ARCHITECTURAL REVIEW BOARD STAFF REPORT

Project #/Name	ARB-2025-27: 400 Rio Rd. West Major Amendment
Review Type	Major Amendment
Parcel Identification	04500-00-00-025C0, 04500-00-00-025C1
Location	400 Rio Road West
Zoned	Light Industrial (LI) / Entrance Corridor (EC) / Airport Impact Area (AIA)
Owner/Applicant	Charlottesville Rio Rd LLC/Williams Mullen (Valerie Long)
Magisterial District	Rio
Context	Most of TMP 45-25C is paved. Additional paving is adjacent on TMP 45-25C1. Chain link fence encloses much of the paved area. The property contains two structures, a brick-faced office building at the front of the site along Rio Rd. and a large metal shed towards the rear of the paved area. To the north, TMP 45-25C2, which is owned by VDOT, splits TMP 45-25C1 into two parts. The portion of TMP 45-25C1 located to the north of TMP 45-25C is characterized by wooded terrain, and no modifications are proposed for this area. To the south across Rio Rd. and separated from it by a solid wood screening fence is the Four Seasons residential development. Additional single-family detached homes are to the east. To the west is a light industrial parcel housing an HVAC company. (See Fig. 1.)

Figure 2: Proposed landscape plan showing the plantings and berm along the frontage, the buildings, travelways, outdoor storage area, and parking.

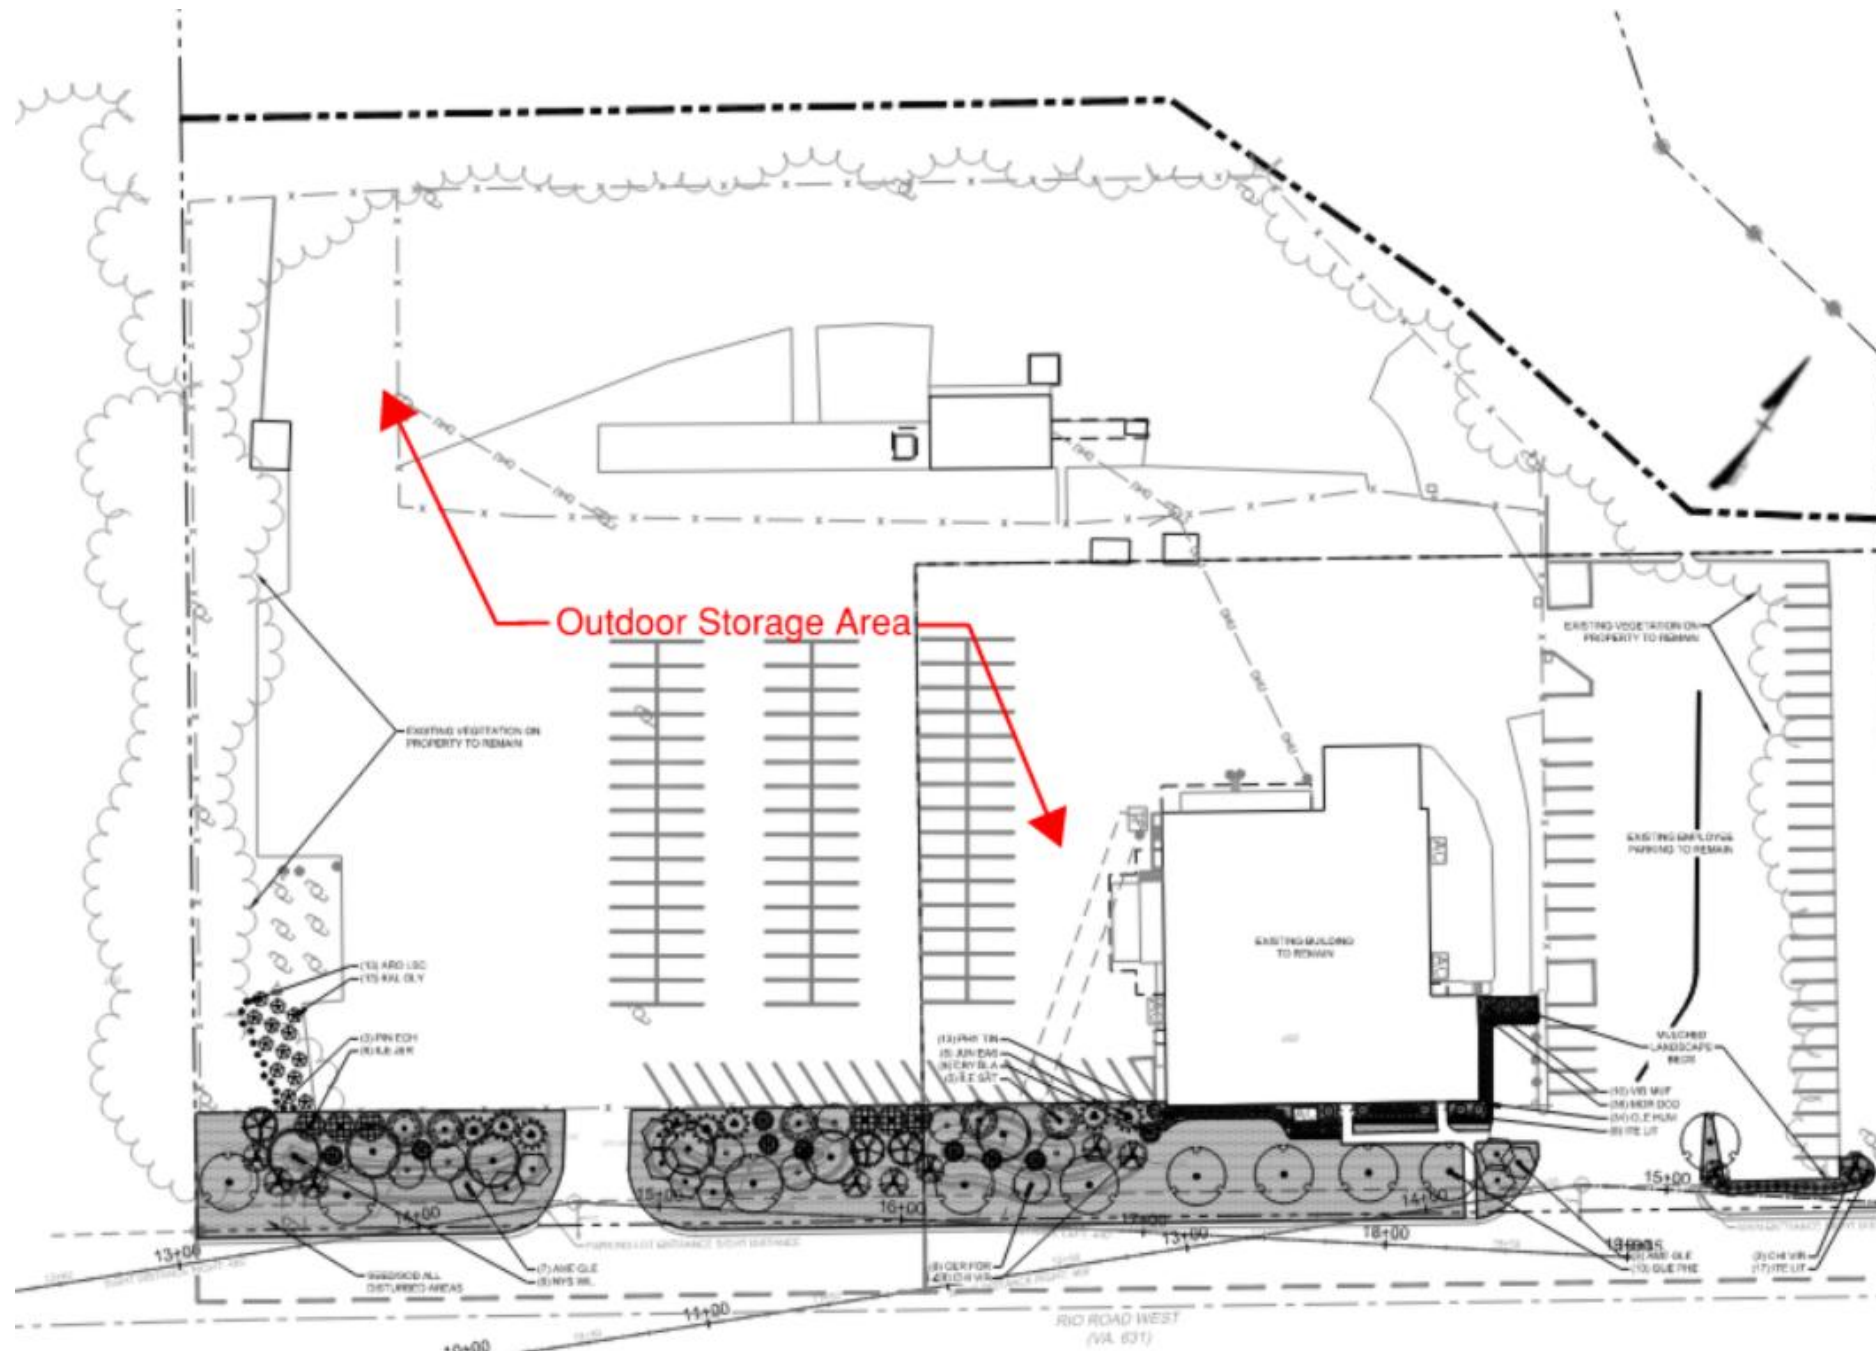
18	The following should be located to eliminate visibility from the Entrance Corridor street. If, after appropriate siting, these features will still have a negative visual impact on the Entrance Corridor street, screening should be provided to eliminate visibility. a. Loading areas, b. Service areas, c. Refuse areas, d. Storage areas, e. Mechanical equipment, f. Above-ground utilities, and g. Chain link fence, barbed wire, razor wire, and similar security fencing devices.	The site and landscape plan closely align with what was shown in the concept plan. The applicant proposes to replace the existing chain link fencing along the southern perimeter of the property, which is situated both east and west of the current building, with black aluminum picket fencing. In the planting area located between the fencing and Rio Road, the applicant proposes to establish a 3-foot-tall berm, which will feature a mix of evergreen and deciduous plants. To further enhance the visual screening of the storage area, one of the conditions of the SP prohibits the placement of materials and equipment that exceed the height of the fence (8 feet) within a distance of 50 feet from the fence line. The installation of a picket fence and landscaped berm will not provide complete visual screening of the storage area from the EC when the use commences. However, the replacement of chain link fencing with aluminum fencing will contribute to a more organized appearance and restricting where items taller than the fence height can be stored will help reduce visibility of items stored within the storage area. Additionally, the mix of plants on the berm exceeds the frontage planting requirements and will enhance the current frontage condition and better integrate the site into the surroundings, resulting in a more orderly and visually appealing development on the corridor.	Provide the proposed locations of loading, service, and refuse areas with the site plan. Show how these locations will be screened from the EC.

19	Screening devices should be compatible with the design of the buildings and surrounding natural vegetation and may consist of: a. Walls, b. Plantings, and c. Fencing.	The section of fence located to the east of the building contains a note indicating what appears to be the length of the fence (28.5 feet), rather than its height. The provided narrative indicates that waste and recycling areas are situated internally within the site and are screened from view; however, these areas are not labeled on the plan for confirmation. Siting these areas, as well as any loading or service areas, in locations where they will not be visible from the EC would be appropriate.	Revise the site plan to correct or clarify the note related to the fence line east of the existing building.
22-31	Lighting	The site plan includes a note stating that no new ground or building-mounted lighting is proposed with this plan.	None.

32	Landscaping along the frontage of Entrance Corridor streets should include the following: a. Large shade trees should be planted parallel to the Entrance Corridor Street. Such trees should be at least 3½ inches caliper (measured 6 inches above the ground) and should be of a plant species common to the area. Such trees should be located at least every 35 feet on center. b. Flowering ornamental trees of a species common to the area should be interspersed among the trees required by the preceding paragraph. The ornamental trees need not alternate one for one with the large shade trees. They may be planted among the large shade trees in a less regular spacing pattern. c. In situations where appropriate, a three or four-board fence or low stone wall, typical of the area, should align the frontage of the Entrance Corridor street. d. An area of sufficient width to accommodate the foregoing plantings and fencing should be reserved parallel to the Entrance Corridor street, and exclusive of road right-of-way and utility easements.	commences, it exceeds the frontage landscaping requirements, aligns with the approved concept plan, and is anticipated to enhance the visual continuity along the EC.

41	No grading, trenching, or tunneling should occur within the drip line of any trees or other existing features designated for preservation in the final Certificate of Appropriateness. Adequate tree protection fencing should be shown on, and coordinated throughout, the grading, landscaping and erosion and sediment control plans.	Grading is limited to the creation of the 3-foot-tall berms between the storage area and the Rio Rd. Entrance Corridor. Near the southwest corner of the site, there are some existing trees that are to remain but no tree protection fencing is shown in this area.	Revise the site plan to show tree protection fencing along the trees that are to remain near the southwest corner of the site.
42	Areas designated for preservation in the final Certificate of Appropriateness should be clearly delineated and protected on the site prior to any grading activity on the site. This protection should remain in place until completion of the development of the site.

1. Provide the proposed locations of loading, service, and refuse areas with the site plan. Show how these locations will be screened from the EC.
2. Revise the site plan to correct or clarify the note related to the fence line east of the existing building.
3. Revise the site plan to show tree protection fencing along the trees that are to remain near the southwest corner of the site.
